2022-04-20

**REQUEST FOR TENDERS
SUPPLY & INSTALLATION OF NEW HANDRAIL
RFQ 24 (2022-04)
ADDENDUM #1**

PEDESTRIAN SAFETY
BUS LAYDOWN
NEW HANDRAIL

PROPOSED HANDRAIL
AT TTC LOOP

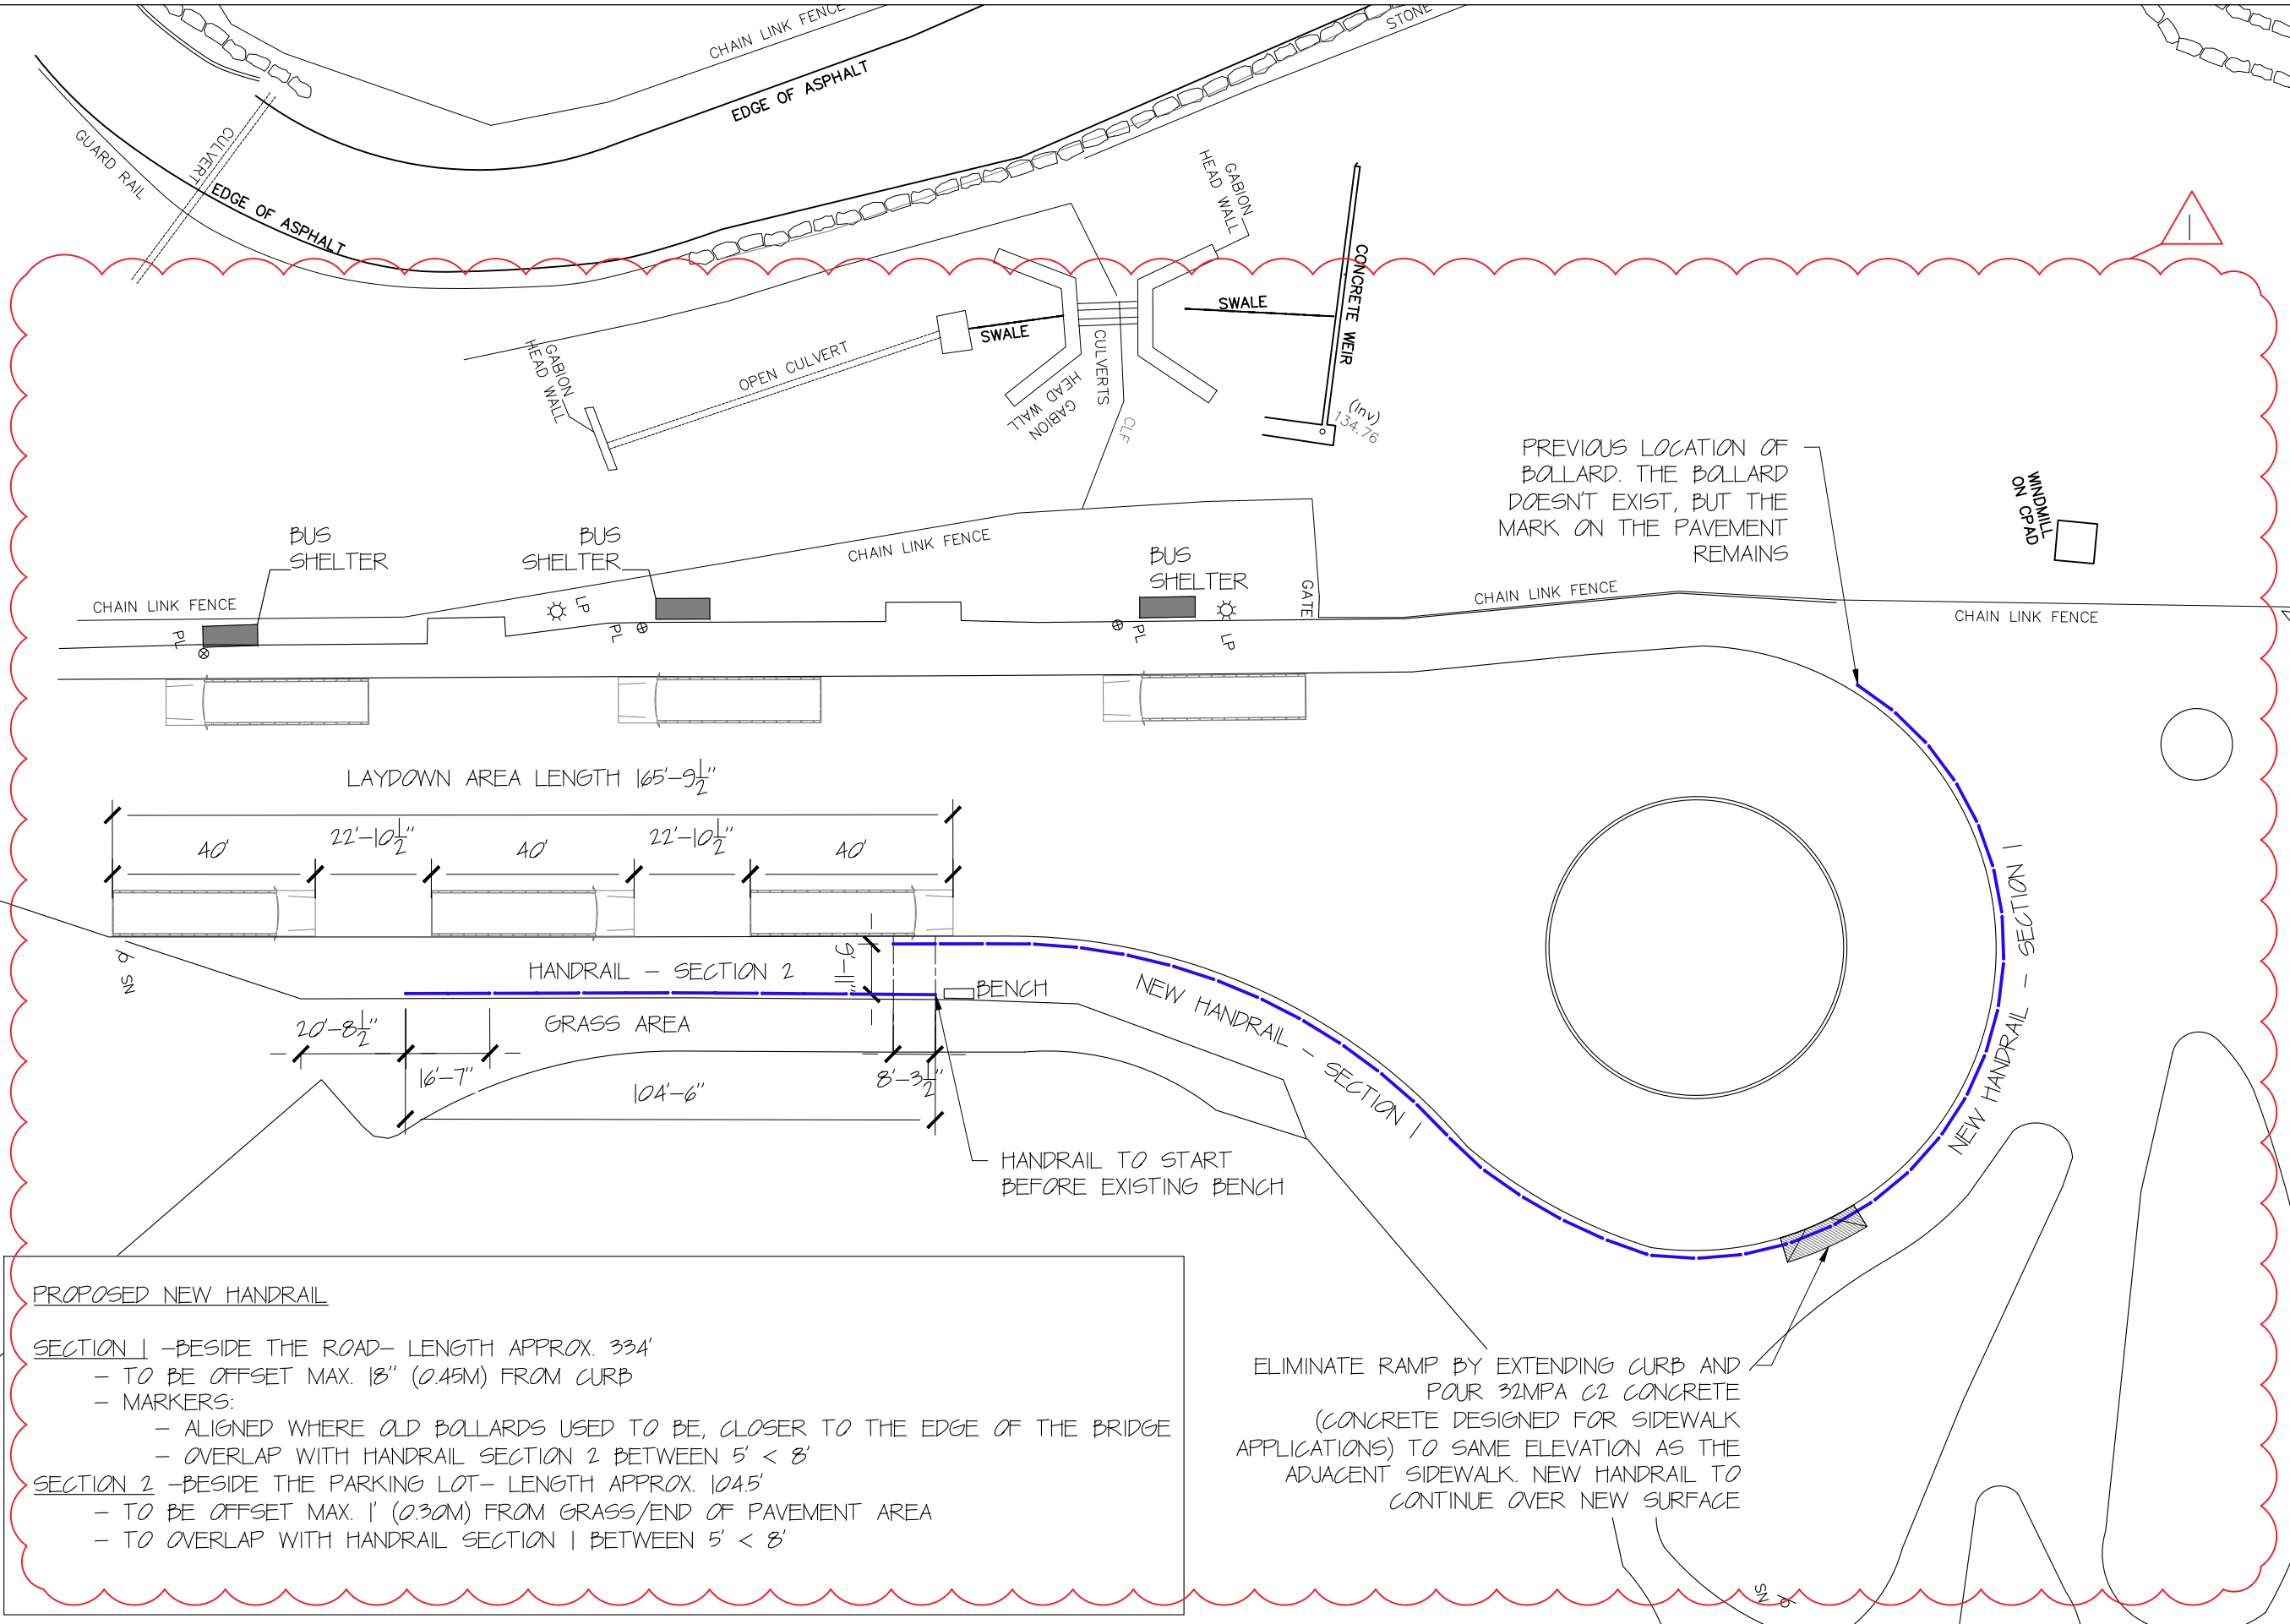
At the TTC loop are the 20'0" sections meant to be 'kinked' in the middle to maintain the 12" off-set of post from the curb?

Is the 12" off-set from the face or back of the curb?

See revised drawings attached. Sections around the loop are now 8' long and will be straight. Sections on the straight areas will be 16' long.

See revised drawings attached. Railing to be offset 18" from the face of the curb.

SECTION 1 - BESIDE THE ROAD - LENGTH APPROX. 334'
- TO BE OFFSET MAX. 18" (0.45M) FROM CURB
- MARKERS:
- ALIGNED WHERE OLD BALLARDS USED TO BE, CLOSER TO THE EDGE OF THE BRIDGE
- OVERLAP WITH HANDRAIL SECTION 2 BETWEEN 5' < 8'

SECTION 2 - BESIDE THE PARKING LOT - LENGTH APPROX. 104.5'
- TO BE OFFSET MAX. 1' (0.30M) FROM GRASS/END OF PAVEMENT AREA
- TO OVERLAP WITH HANDRAIL SECTION 1 BETWEEN 5' < 8'

**PROPOSED HANDRAIL
AT SUMMER CAMP DROP OFF**

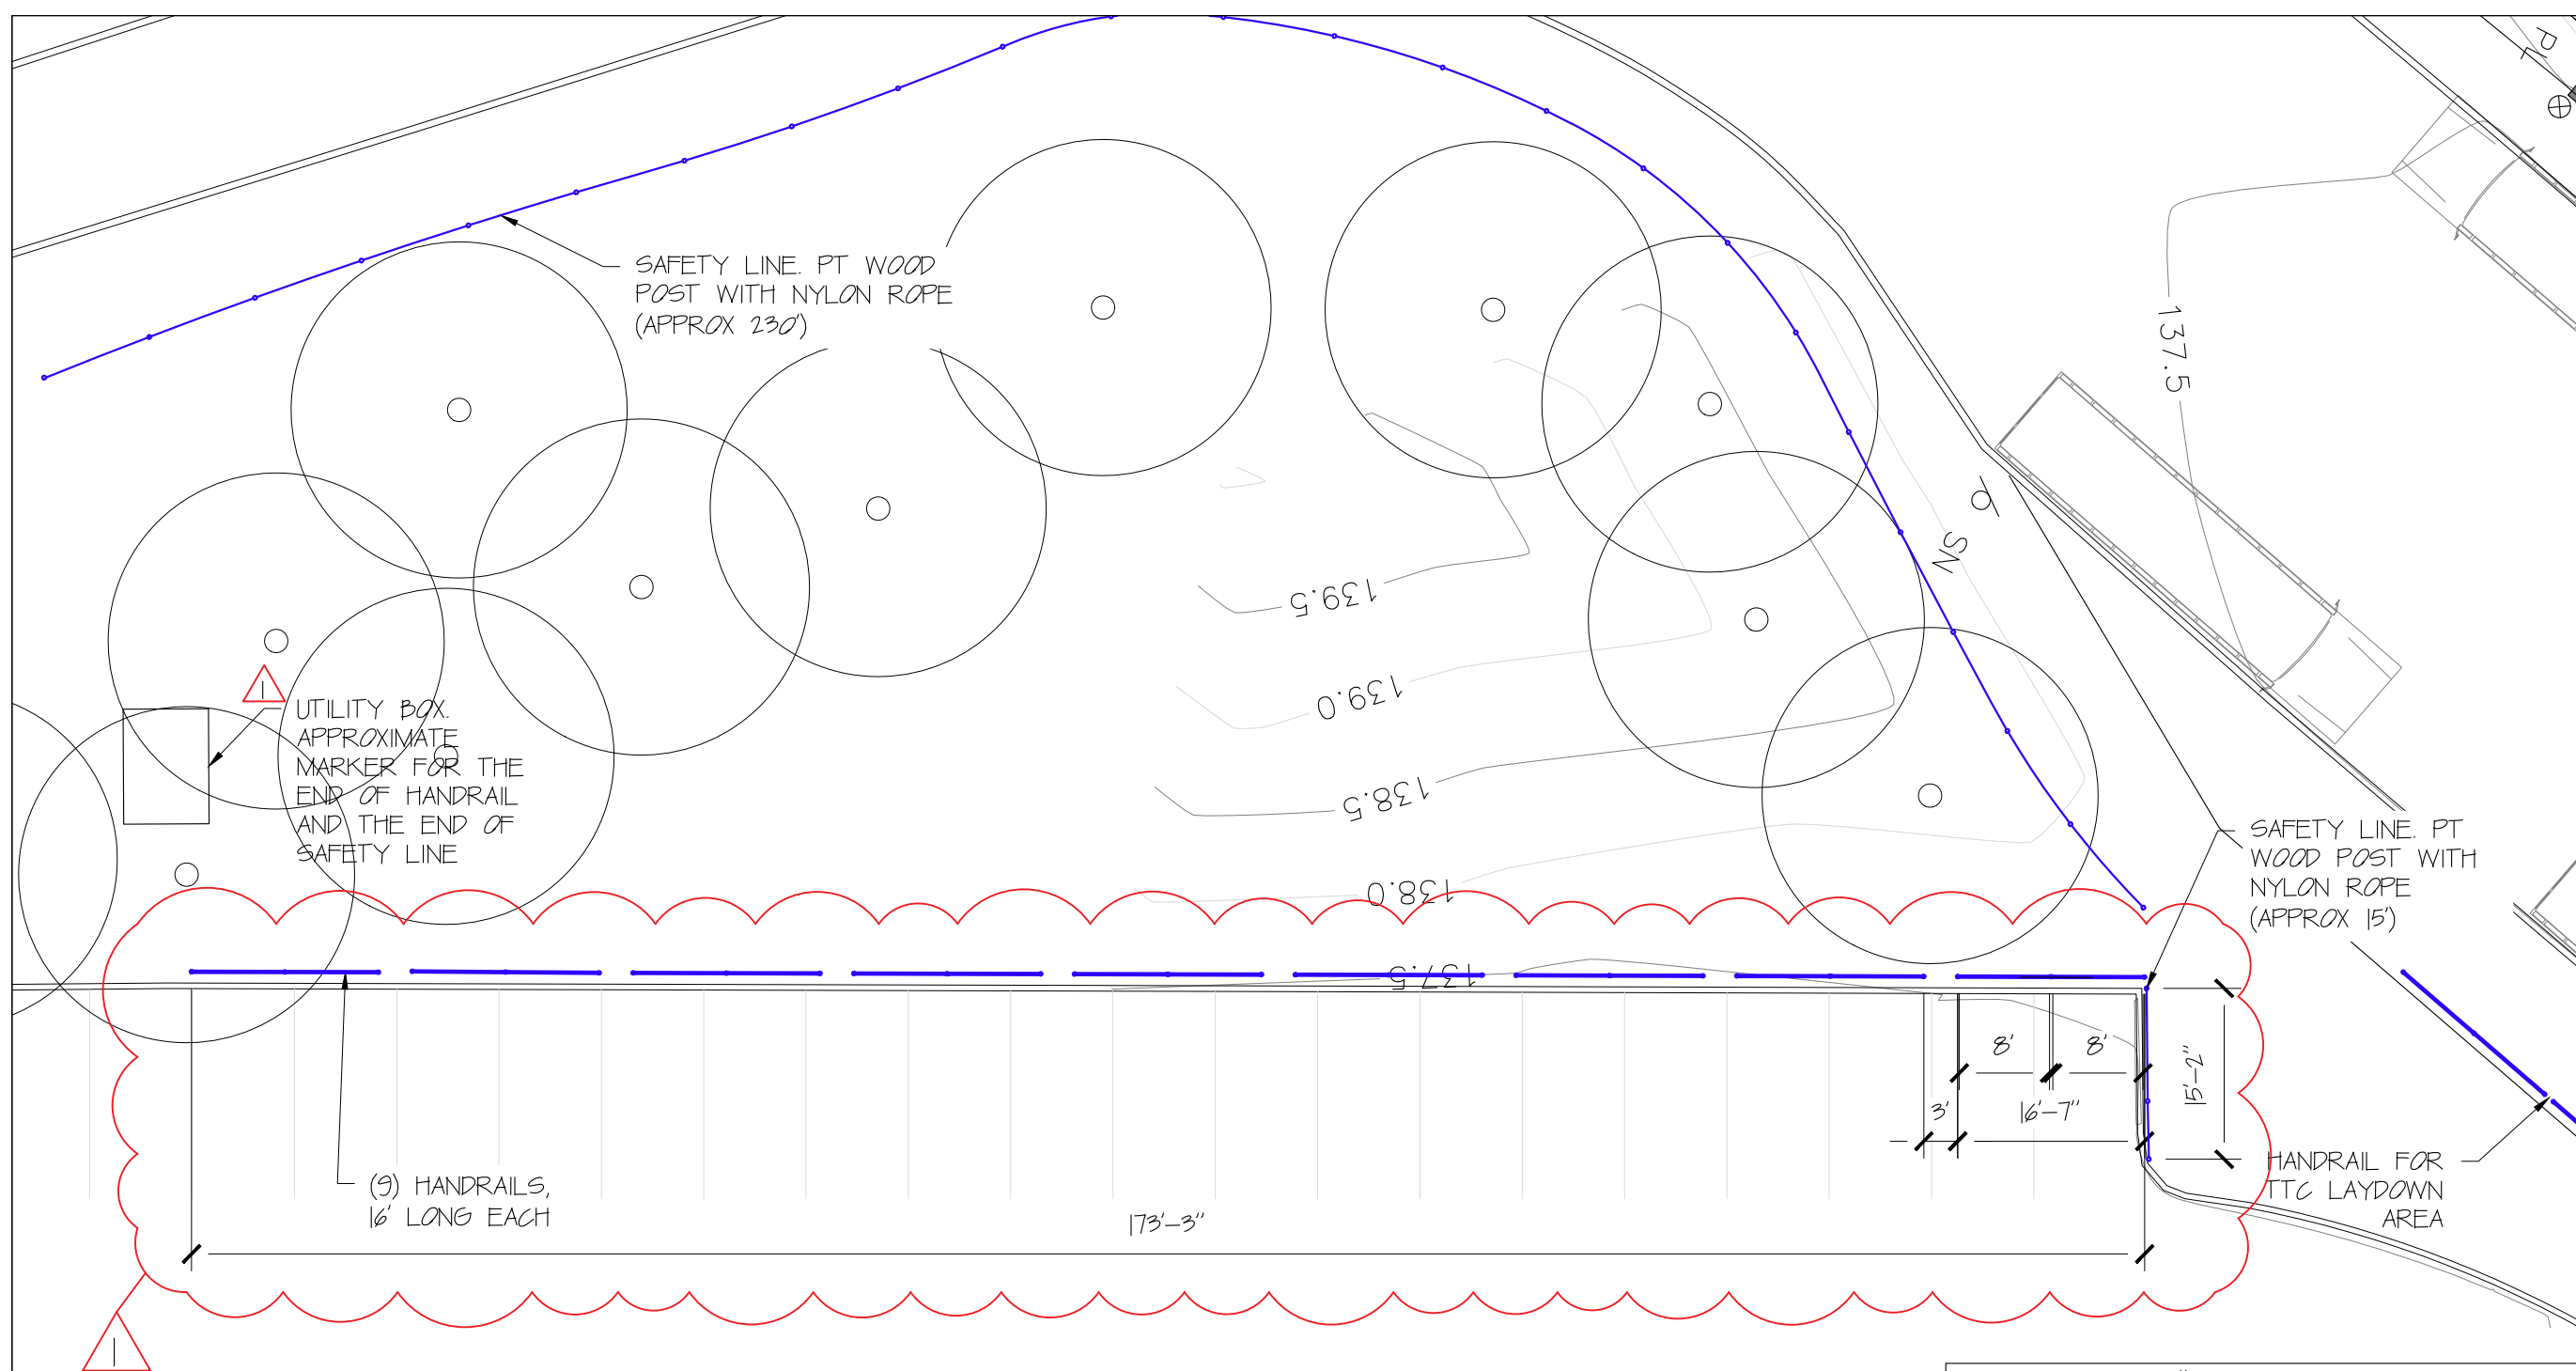
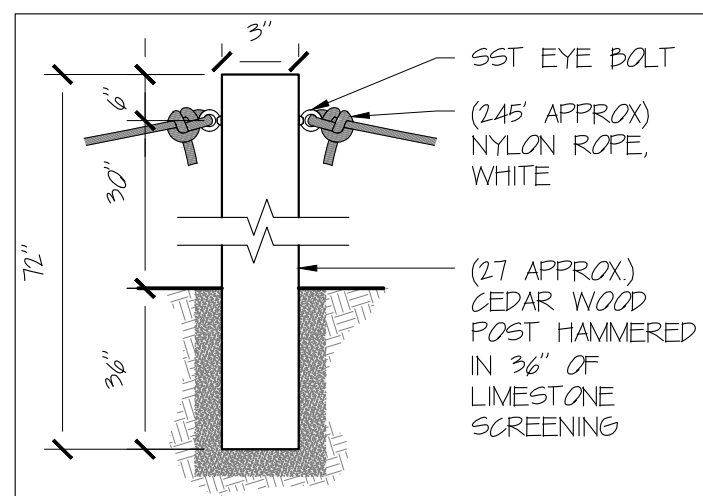
9. Handrail Installation at Summer Camp Drop-Off.
 - a. Install new 2" diameter, 304-grade min. stainless steel handrail of 20' length (sub-segmented into 10' long), with (3) post of 44" height, end caps on (3) posts, with a welded top and mid rail (of same material and size).
 - b. Top rail center to be 3" below the top of the post.
 - c. Mid rail center to be 20" below center of top rail.
 - d. Posts anchored into new concrete footing referred on previous point, using a 5" diameter flange (post to be welded to flange) with three to four wedge anchors.
 - e. Anchors to be approved by client before installation.
 - f. All materials to be used must be anti-corrosive. Space each 20' segment by 36" o/c. The installation must be 18" from the edge of curb.

9. Handrail Installation at Summer Camp Drop-Off.
 - a. Install new 2" diameter, 304-grade min. stainless steel handrail 42" high, with a top and mid rail (of same material and size).
 - b. Top rail at 42"

- c. Mid rail at 22"
- d. Sections are 16' long with a mid-post.
- e. Posts anchored into new concrete footing using a flange and wedge anchors.
- f. Anchors to be approved by client before installation.
- g. All materials to be used must be anti-corrosive. Space each railing segment by 36" o/c. The installation must be 18" from the face of curb or edge of concrete pavement

**HANDRAIL DETAILS**
16' SEGMENT MADE OUT WITH 2"Ø SST SECTION ANCHORED TO A 12"X12"X3' CONCRETE FOOTING. HANDRAIL TO HAVE 18" OFFSET FROM CURB'S EDGE. SEE DRAWING A1.05

HANDRAIL DETAIL 8FT SEGMENT @ TTC LOOP -ROADSIDE- PREFAB HANDRAIL

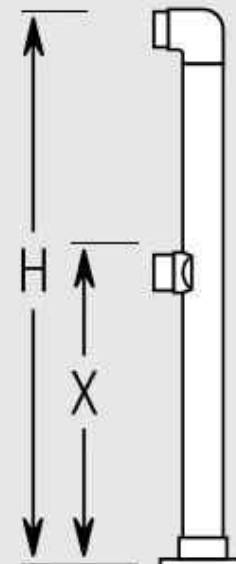
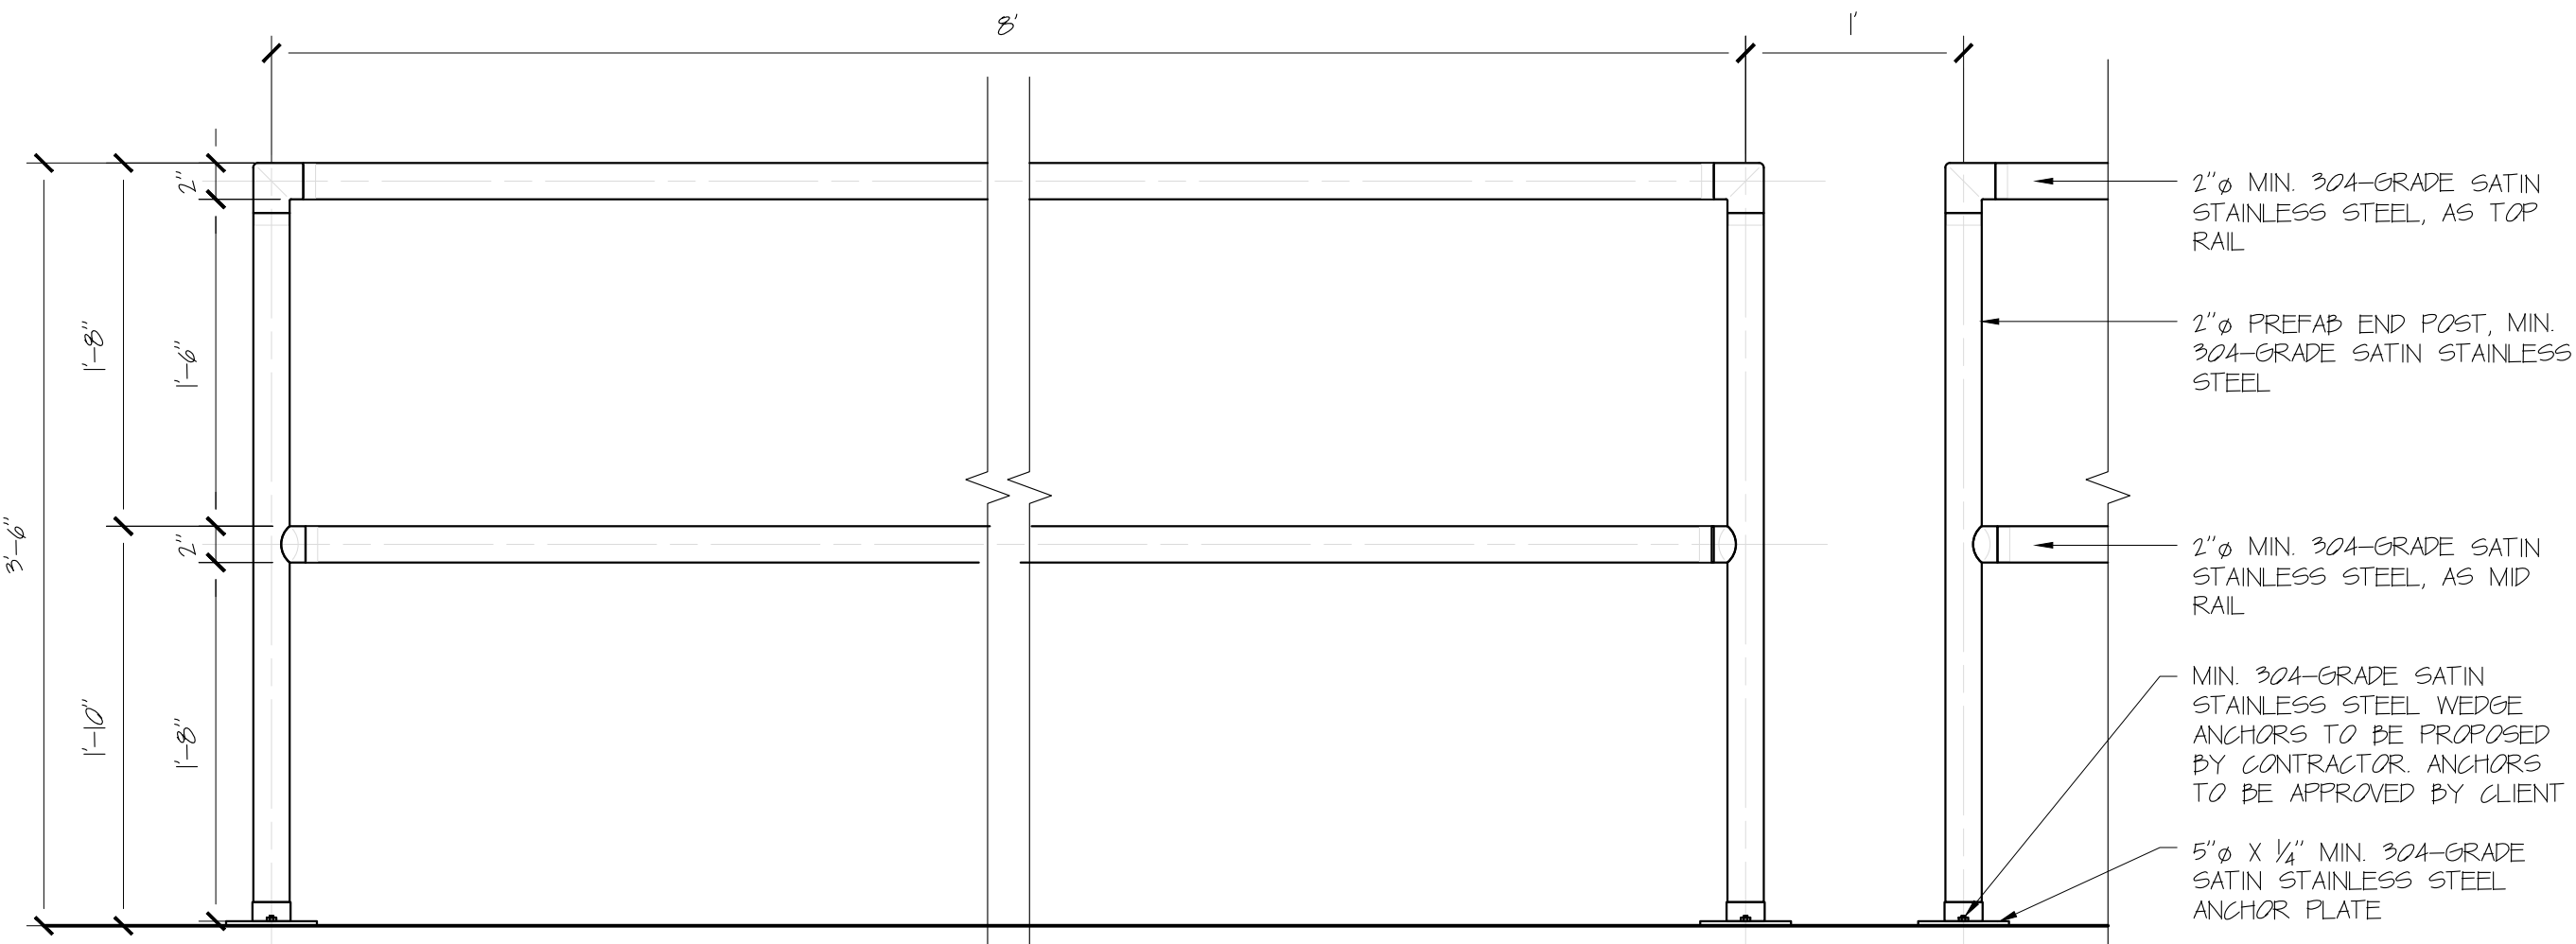
As per the scope of work the material should be 2" diameter, 304-grade stainless steel at a minimum. Please advise, the pipe schedule that is required for the material.

What is the wall thickness for the SS tubing? Recommended is 16 ga.. Sometimes 1/8" wall is used – but more expensive. Availability of either will depend on supplier at the time of ordering.

Are the joints to be TIG welded and buffed to remove staining? There will be no sharp edges. Or do you want welds ground down and polished? Much more labour intensive & costly.

See revised drawings attached. Railing product has been revised and is now bonded using structural adhesive.

EACH RAIL SEGMENT IS 8' LONG WITH (2) 42" TALL END POST ANCHORED TO (1) PLATE PER POST, (3 OR 4) ANCHORS PER PLATE, (1) 8' TOP RAIL AND (1) 8' MID RAIL. END POSTS AND CONNECTORS ARE PREFAB BY MANUFACTURER. RAILS TO BE GLUED TO END POSTS FOLLOWING MANUFACTURE'S INSTRUCTIONS.
